REVISED DECISION OF THE PLANNING ADMINISTRATOR

**URBAN GROWTH PRELIMINARY DECLARATION / CLASS 3 SITE PLAN
REVIEW / CLASS 2 ADJUSTMENT / CLASS 2 DRIVEWAY APPROACH PERMIT
/ TREE REGULATION VARIANCE CASE NO.: UGA-SPR-ADJ-DAP-TRV22-01**

SUMMARY: Development of a new industrial use building with associated site work.

LOCATION: 4400 Block of Turner Rd SE

A-2

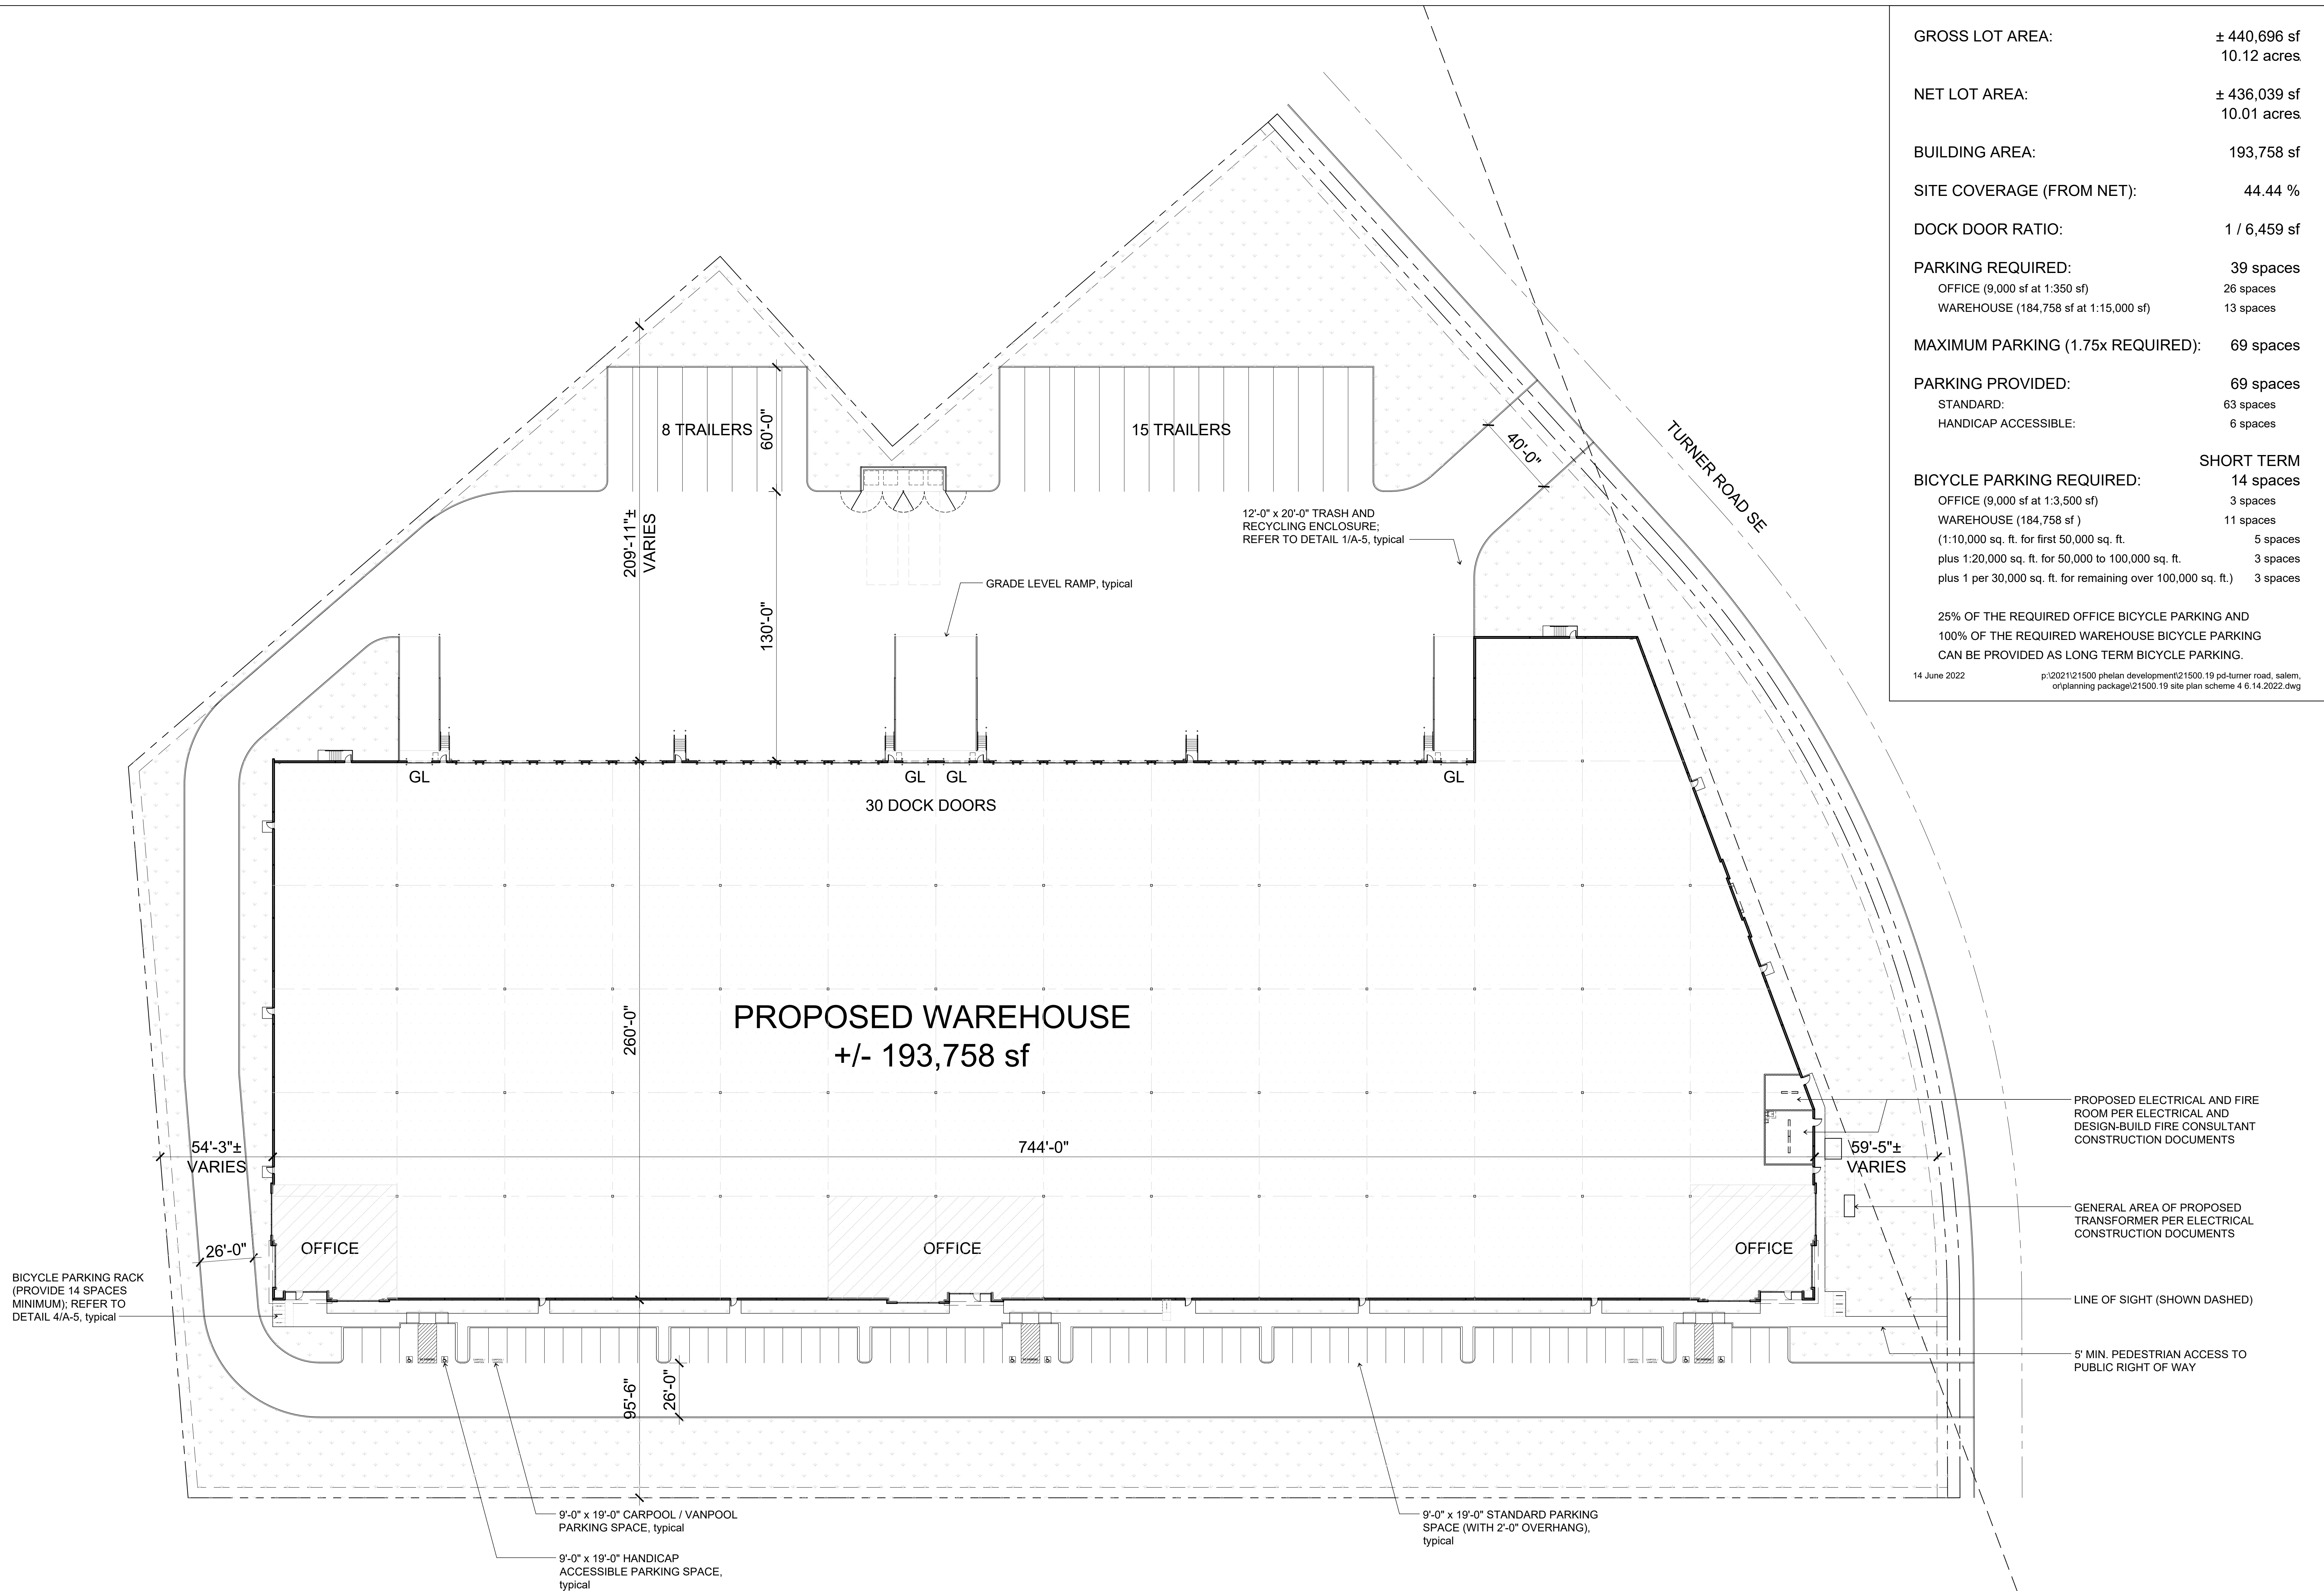
- Condition 3:** At the time of building permit, the applicant shall adjust the parking area to include only the 67 parking spaces allowed by the maximum parking requirement.

- Condition 4:** At the time of building permit review, the applicant shall provide bumper guards or wheel barriers for the parking spaces adjacent to a walkway only five feet in width to prevent parked vehicles from encroaching into the pedestrian accessway.

The proposed site plan indicates that 69 parking spaces will be provided on site, 4 carpool/vanpool parking spaces are indicated on the site plan, and no compact spaces

Condition 4: At the time of building permit review, the applicant shall provide bumper guards or wheel barriers for the parking spaces adjacent to a walkway only five feet in width to prevent parked vehicles from encroaching into the pedestrian accessway.

TREE INFORMATION

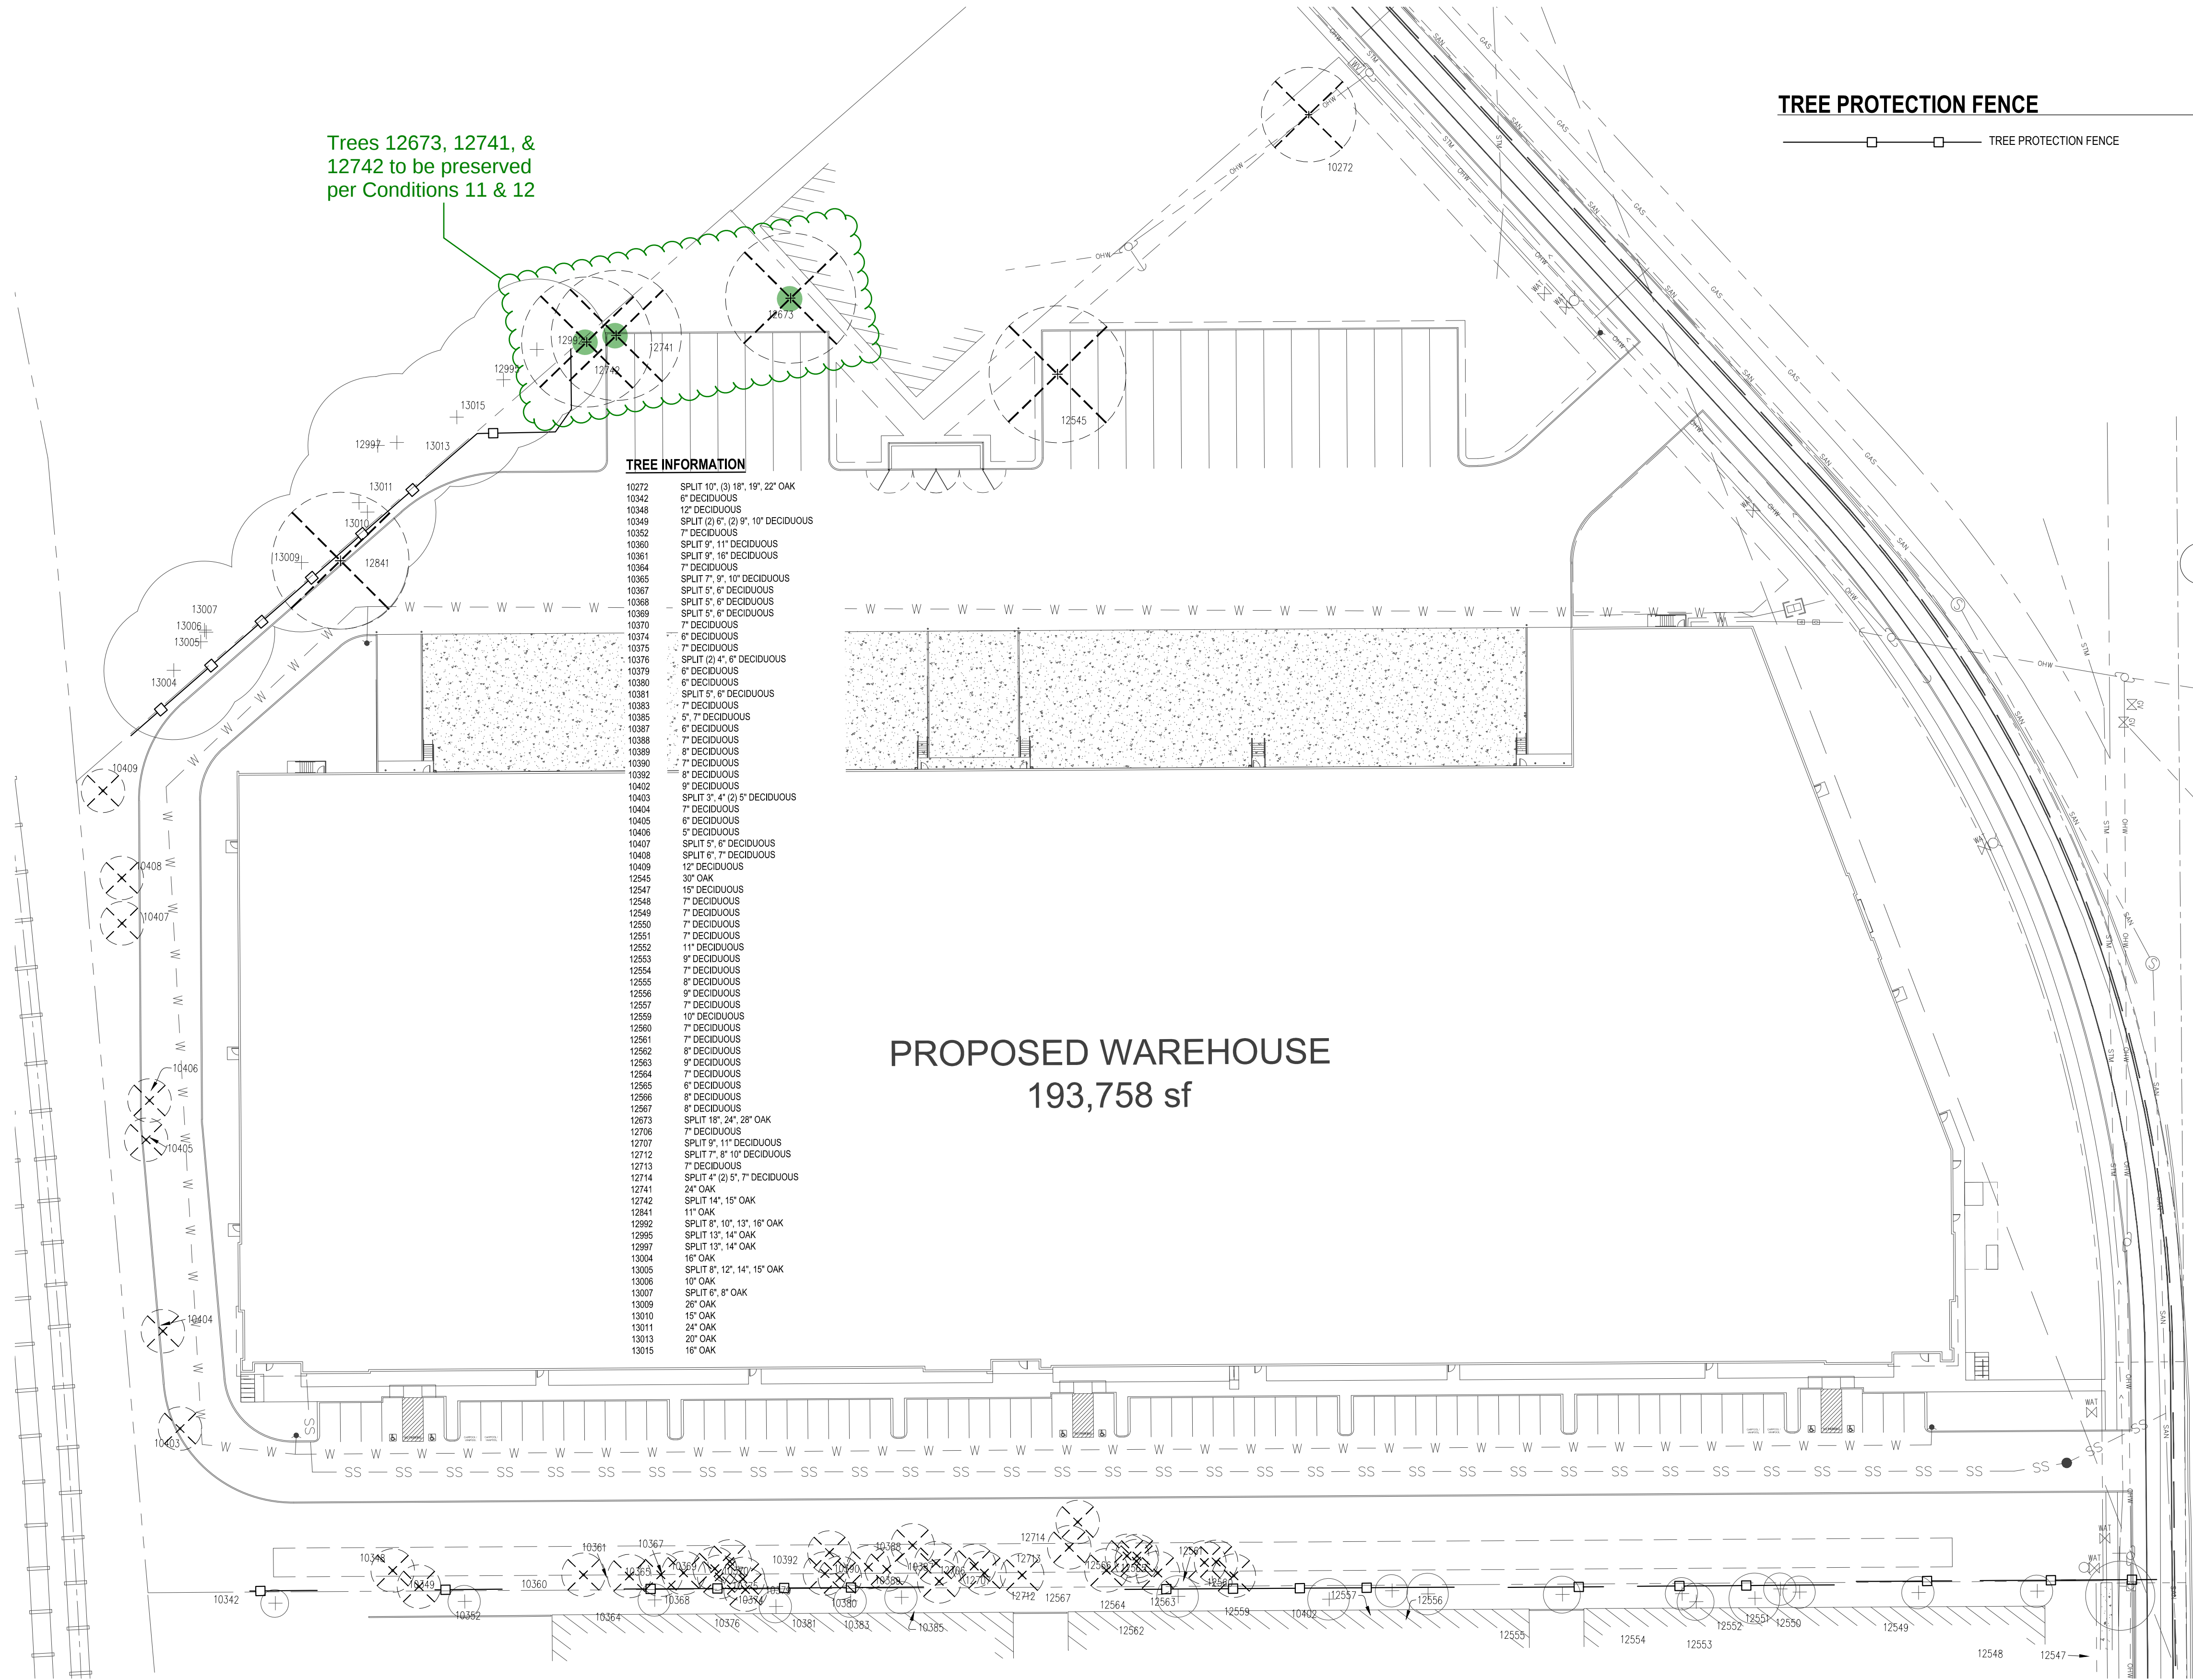
Condition 11: Two significant trees, a split trunk Oregon White Oak with the largest measurement of 28 inches dbh (Tree No. 12673) and a 30-inch dbh Oregon White Oak (Tree No. 12741), shall be retained and preserved on site, with the required protection measures provided for significant trees during construction (SRC 808.046). At the time of building permit review, the applicant shall provide updated landscaping indicating the critical root zone of these trees and all protection measures, and updated plans reducing the trailer parking area to ensure protection of these trees.

Condition 12: Tree No. 12742, a split trunk Oregon White Oak with the largest measurement of 15-inch dbh, shall also be retained and preserved on site, with the required protection measures provided for significant trees during construction (SRC 808.046).

Finding: The applicant submitted a tree plan in conjunction with the proposal identifying a total of four significant trees (Oregon White Oak greater than 20 inches in diameter-at-breast height (dbh), or any other tree with a dbh of 30 inches or greater) on the property. In the written statement for the Tree Variance, the applicant requests to remove all four significant trees due to their locations severely limiting the development of the site. However, the applicant proposed minor changes to the site plan after the application was deemed complete and notice was sent, including a request to remove two additional trees under this Tree Variance to accommodate an expanded vehicle use area not required by code; the initial proposal requested removal of only two significant trees. As such, Staff finds that the two additional trees requested for removal do not meet the criteria for hardship, as the site is able to be developed without their removal, as evident with the initial proposal for the development. In addition, the location of the two trees in question, Tree No. 12673 and Tree No. 12741, would only limit the development of an expanded large-vehicle trailer parking or storage area, which is not considered required parking under the Salem Revised Code. The development is still able to provide a separate area of fifteen trailer parking spaces, and an additional eight spaces does not render the development unusable or create an unreasonable hardship. As such, the following condition applies:
